# RESPONSE TO CUMBERLAND DESIGN EXCELLENCE PANEL COMMENTS – DA2020/0542

14–22 MARY STREET,  
AUBURN

## Response to Cumberland DEP Issues - 14-22 Mary Street, Auburn

KEY PLAN LEVEL 2

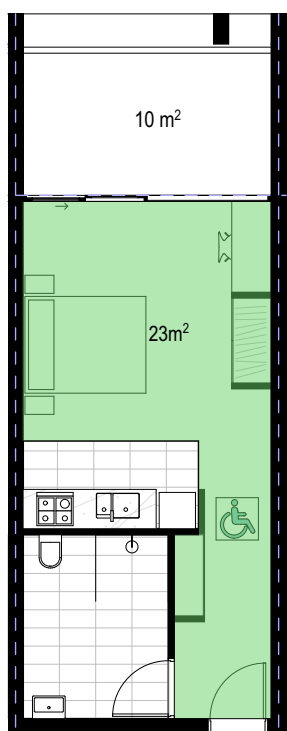
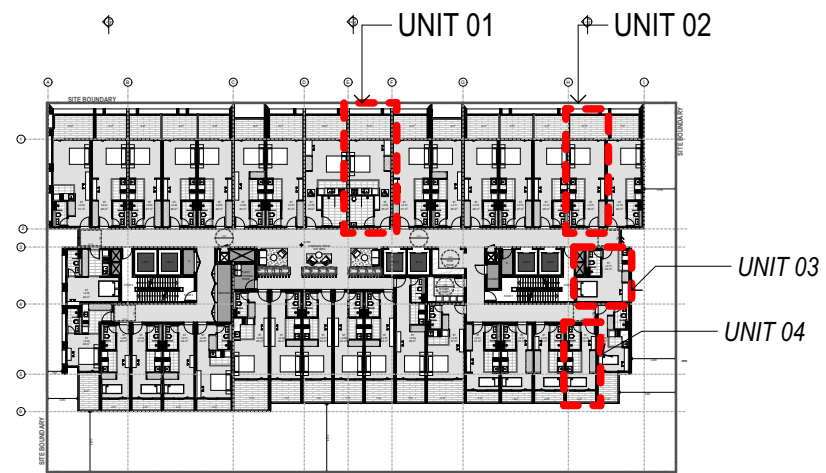
- 2) Affordable Rental Housing SEPP
- b. Accommodation size - further details are required to confirm compliance.

- All single lodger units achieve a minimum of 12m<sup>2</sup> and do not exceed a maximum of 25m<sup>2</sup> which is exclusive of the bathroom and kitchen area.
- All double lodger units achieve a minimum of 16m<sup>2</sup> and do not exceed a maximum of 25m<sup>2</sup> which is exclusive of the bathroom and kitchen area.

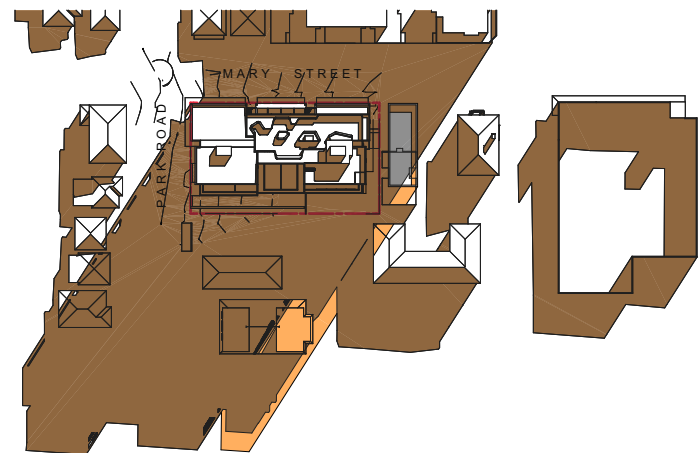
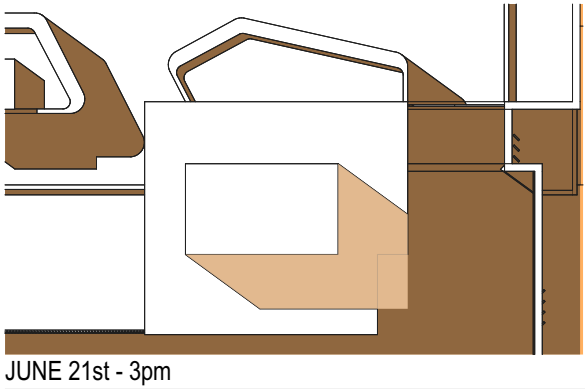
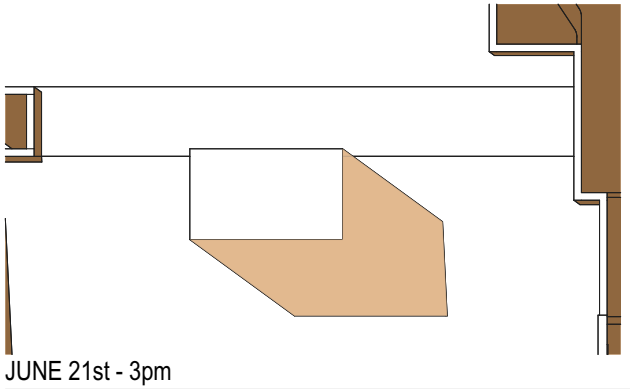
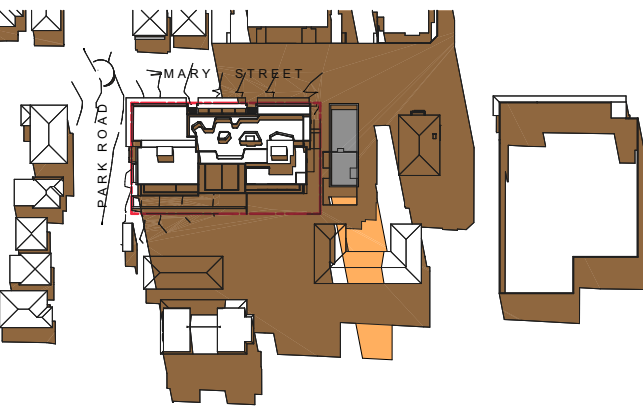
The proposal will potentially result in difficulties in developing the adjoining properties to the east (as 8 Mary Street is a heritage item), as it provides a setback to these properties where none is required by the DCP (and therefore may necessitate a similar setback being provided on the adjoining site when redeveloped). This issue should be considered in determining how the proposal will respond to other issues including the excessive bulk, loss of vegetation and stormwater.

Shadow cast from the lifts and stairs, which breach the height, don't cast any additional shadow over the surrounding context.

DEEP SOIL ZONE

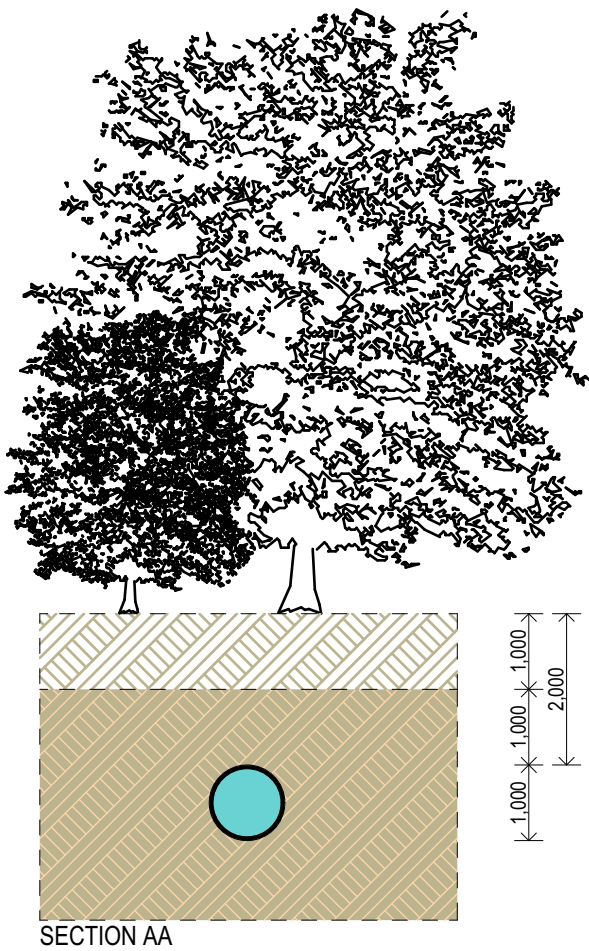
b. To ensure that development is sensitive to the landscape setting and environmental conditions of the locality.

The site, which is located within “Auburn’s Town Centre Boundary”, accommodates planted entries to both the residential and boarding house lobbies at ground floor level along with planted pockets in-front of the commercial units along Mary Street (Mary Street will also accommodate the existing trees). A deep soil zone is located all along the eastern and southern boundaries, which will accommodate new vegetation and new trees. It is the intended that the new vegetation and trees will replace the existing trees removed over time and also provide more greenery and privacy along both the eastern and southern boundaries, than what is there already. Adequate deep soil will be applied to the zone where the proposed water main is located to accommodate the growth of these new trees.

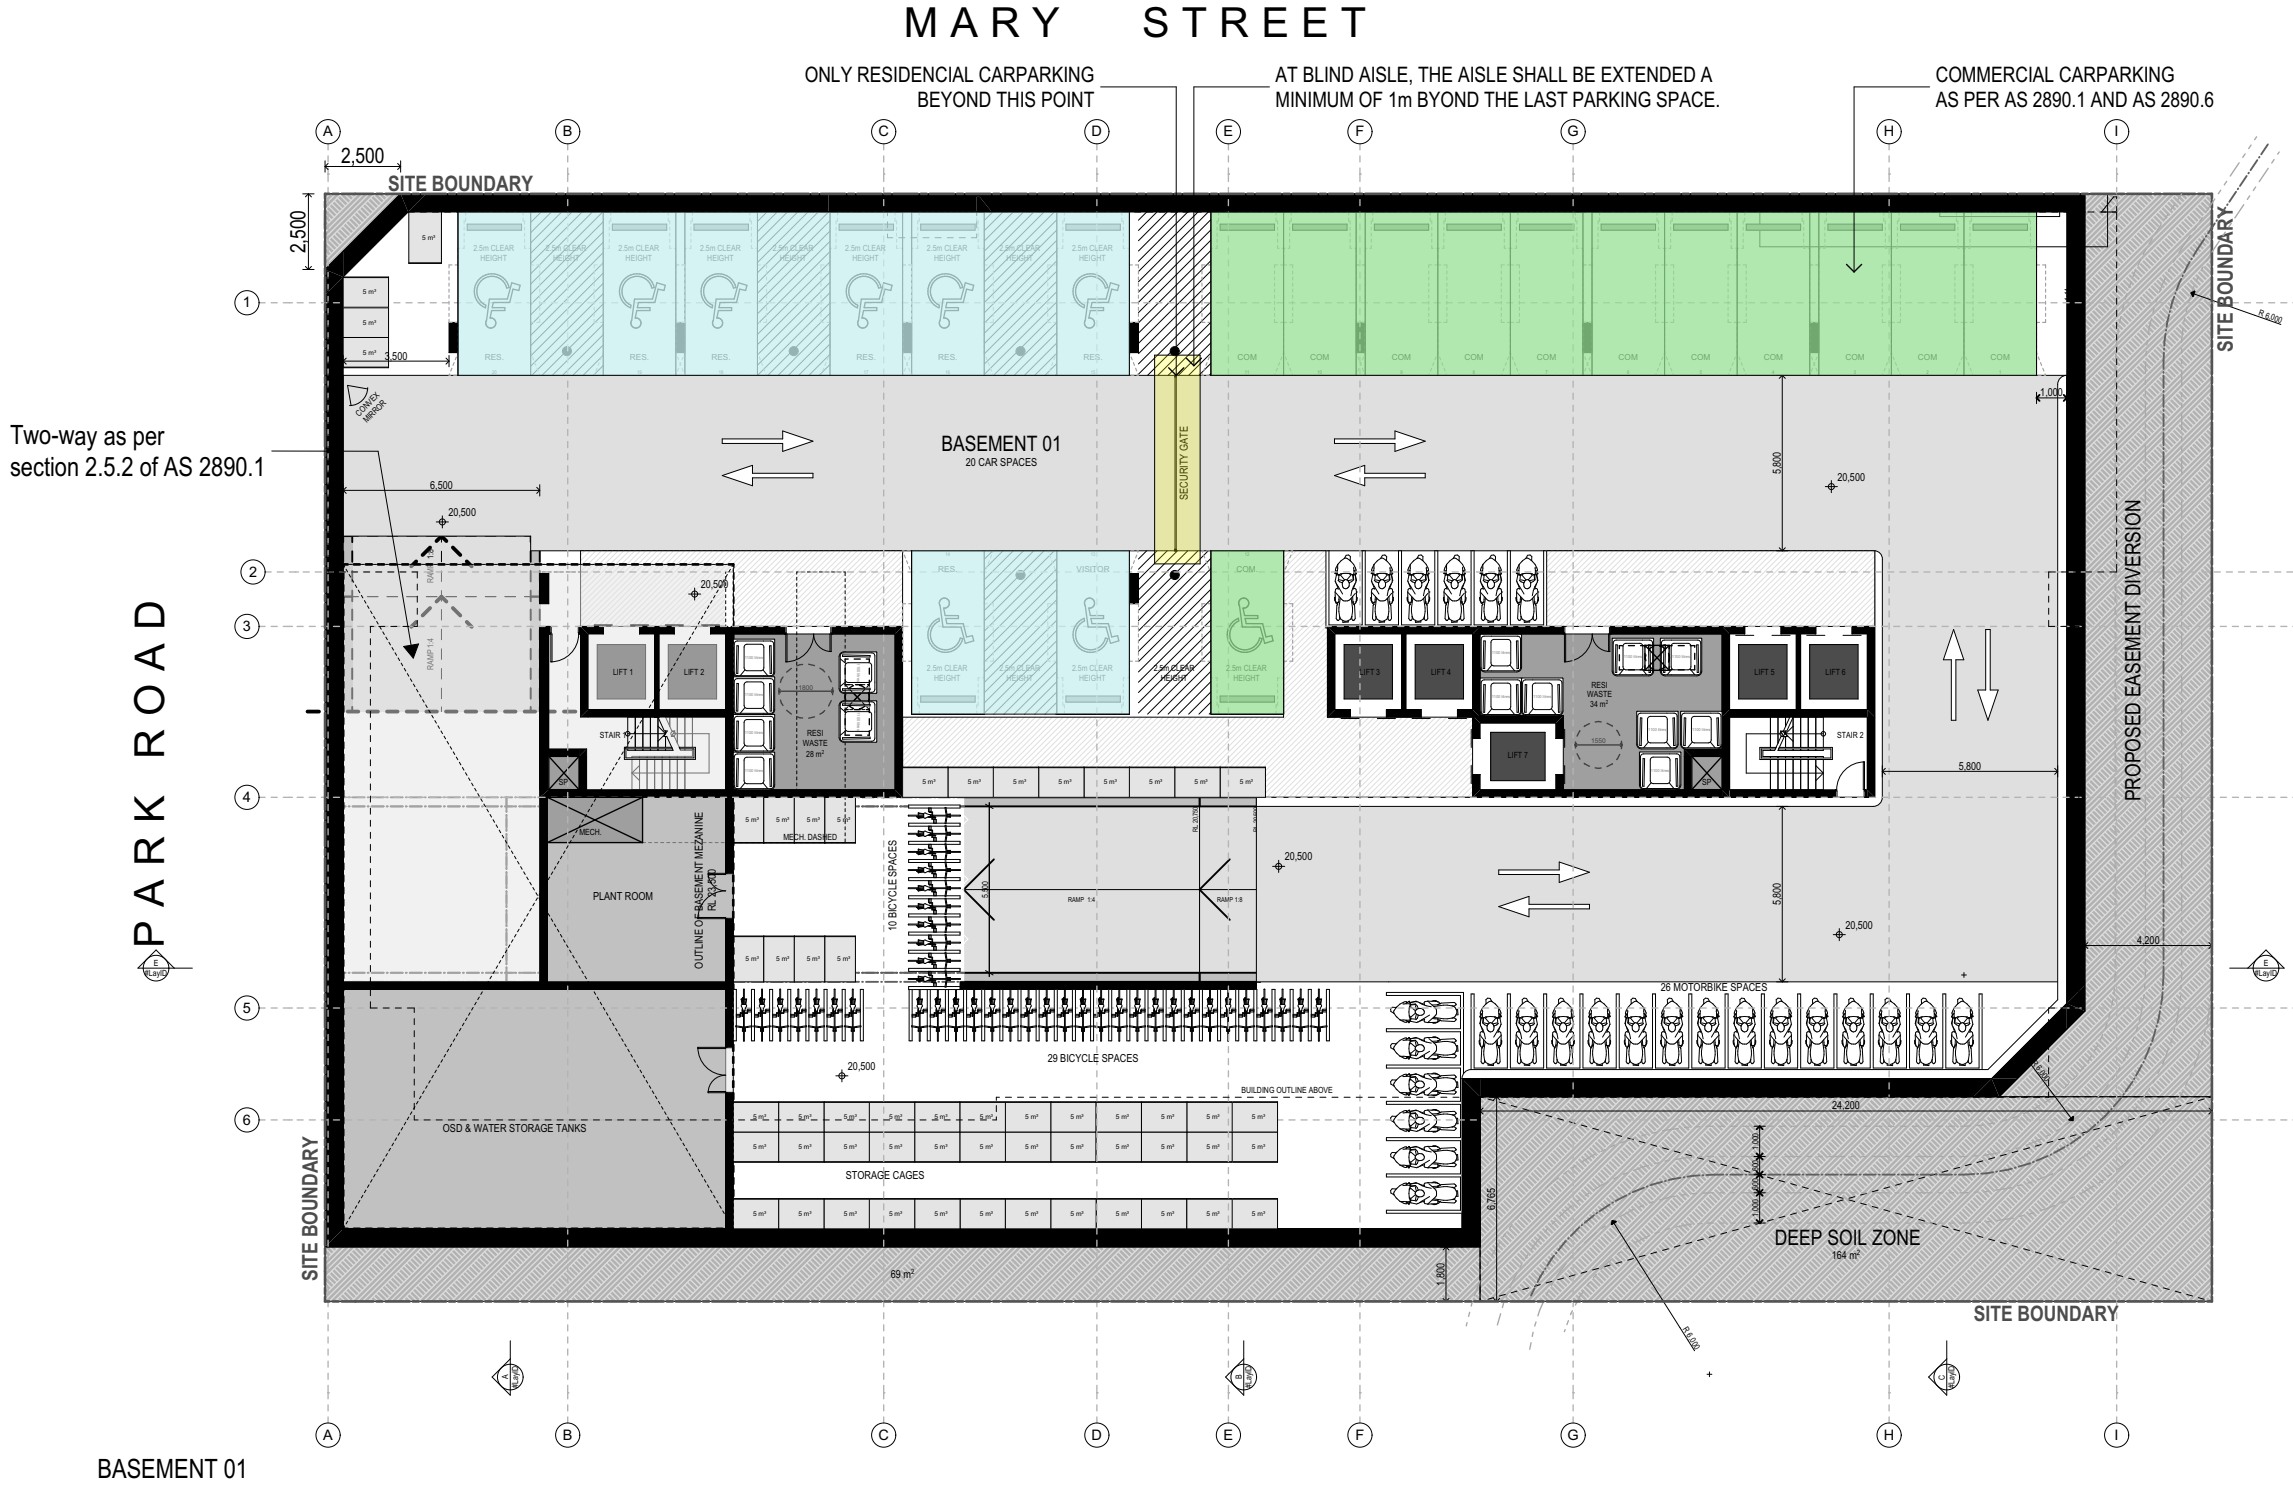
- i. Commercial and residential parking spaces shall be separated. Turning area shall be provided at the separation area blind aisle.
- ii. Width of the commercial and visitor parking spaces shall be minimum 2.6m. All the necessary dimensions shall be annotated on the plans.
- iii. Two-way access ramp width shall be minimum 6.1m. Details shall be annotated on the plan.

Commercial and residential parking spaces are separated by a security gate, and a blind aisle of min. 1m is provided at the end of the commercial parking bays.

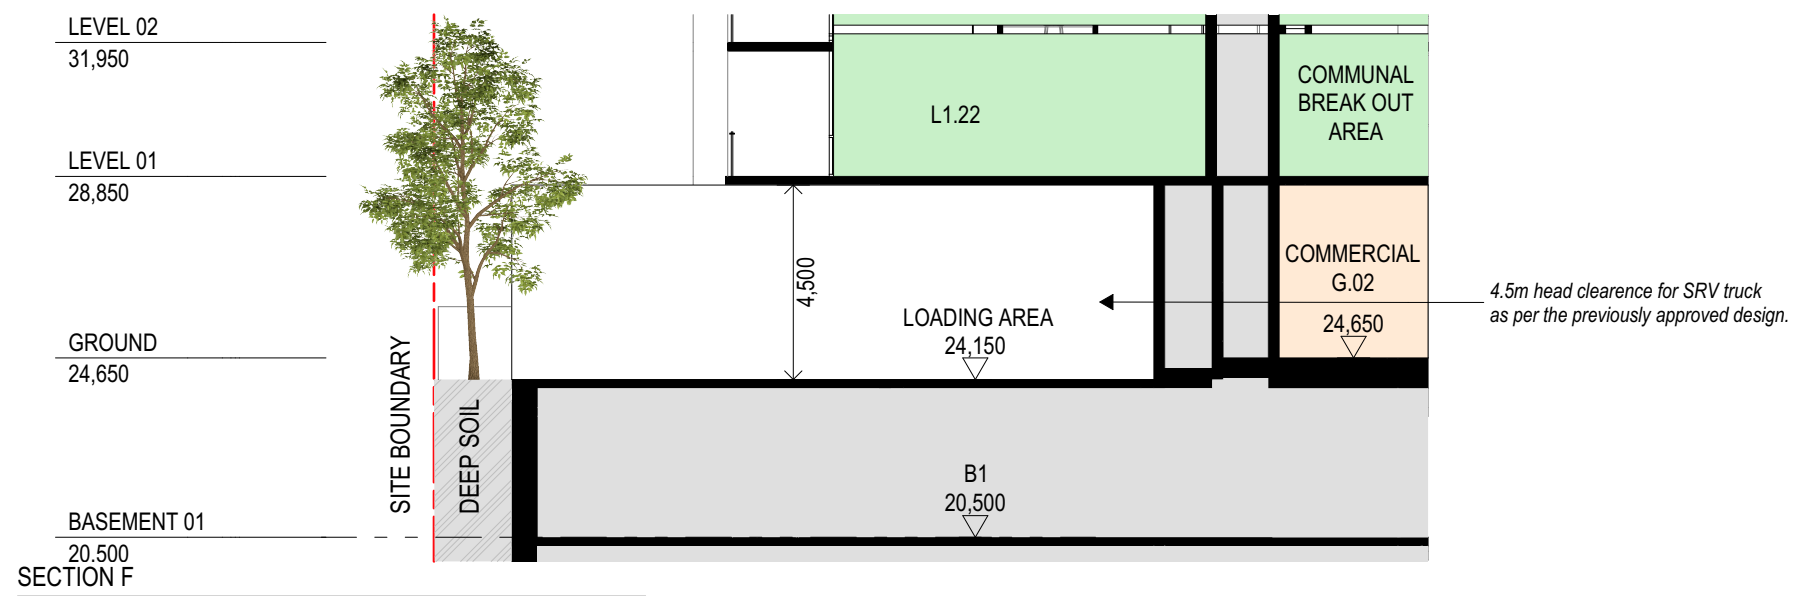
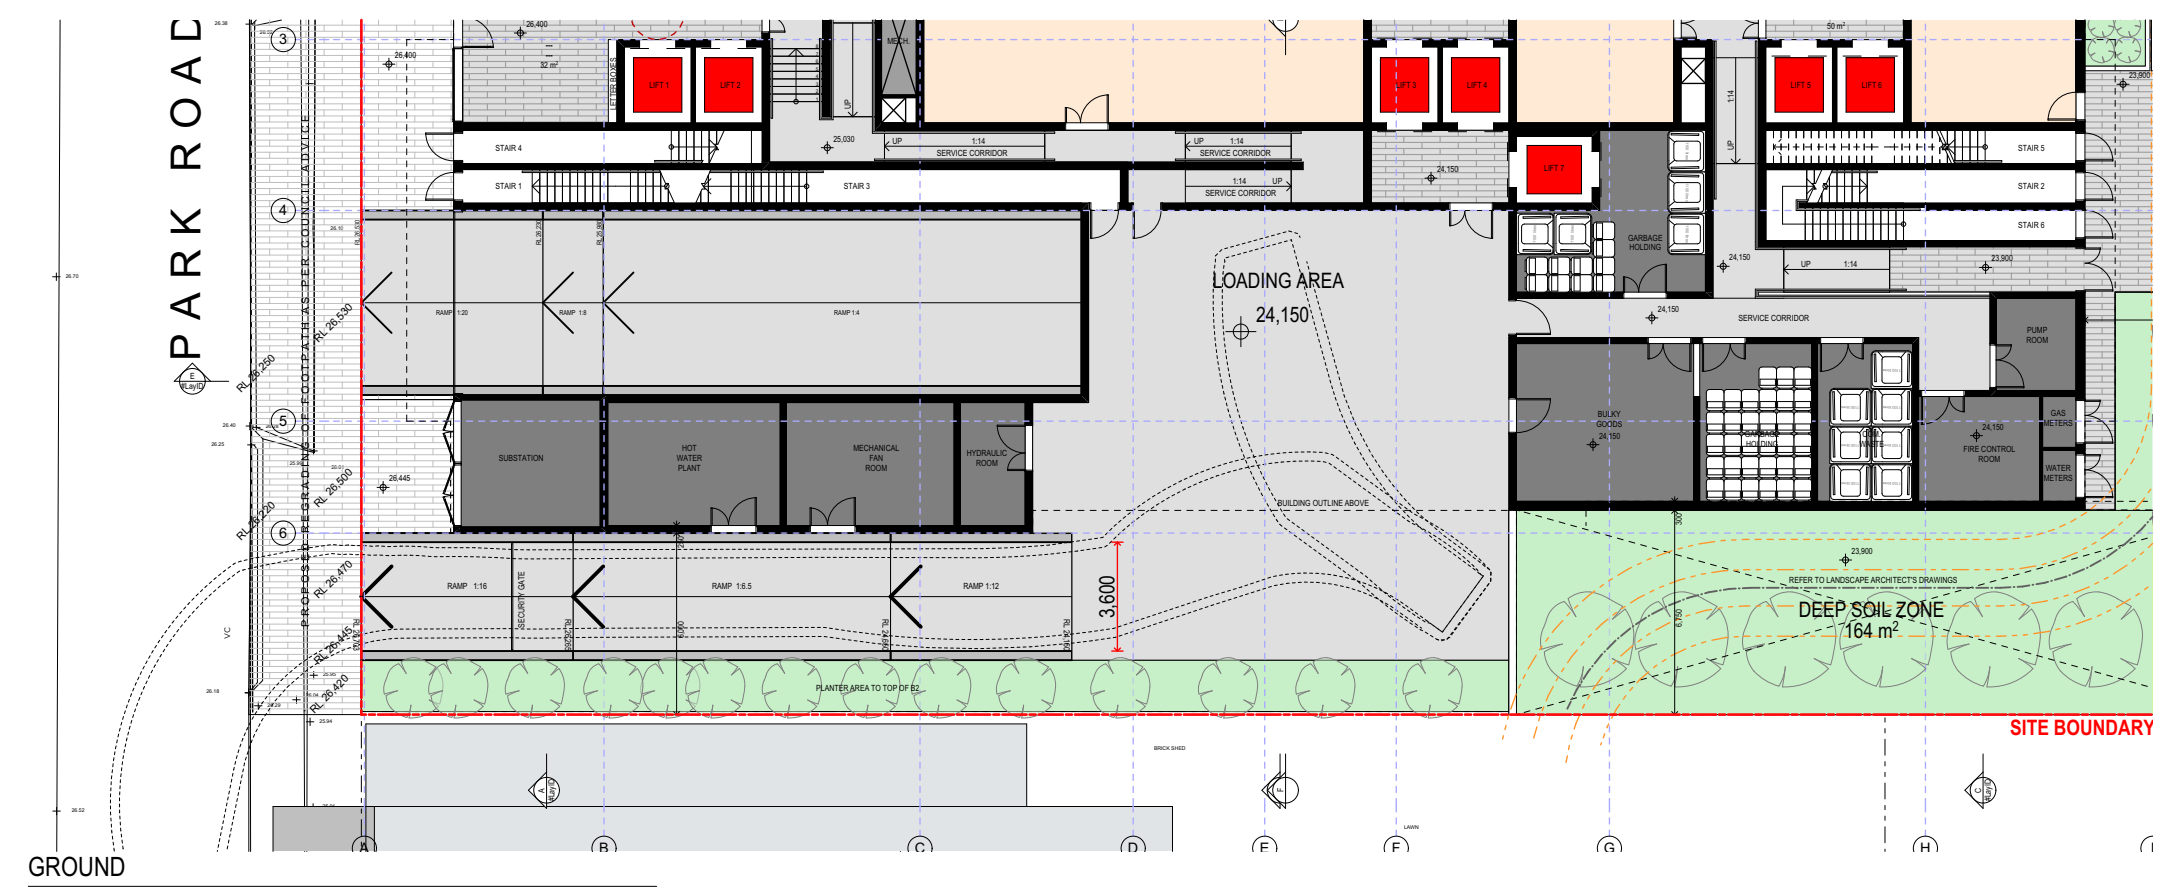
- i. Driveway width for truck access shall be minimum 3.5m. Detail shall be annotated on the plans.
- ii. Traffic report shall address the loading requirements. Minimum two loading areas are required as per Council's DCP. Loading area shall be designed for at least Medium rigid vehicle (MRV) access. Delivery trucks shall enter and leave the site in a forward direction. In this regard detail swept path analysis shall be submitted.
- iii. Detail left turn entry/exit swept path analysis shall be provided to ensure truck manoeuvring will not have adverse impact on street traffic and onstreet parking. The plan shall also show the kerb and road centre lines details.

Driveway width for truck access is 3.6m.  
Loading requirements and swept path as per the approved DA - Ref N° DA-32/2017  
Loading dock has been designed to accommodate the ramp grade and loading requirements of a SRV truck accessing the loading dock. MRV trucks reverse into the top of the ramp only, which is consistent with the previously approved design. Testing with the ground clearance templates in accordance with AS28090.2-2002 indicates that both truck sizes can be accommodated on the respective sections of the ramp without scraping.
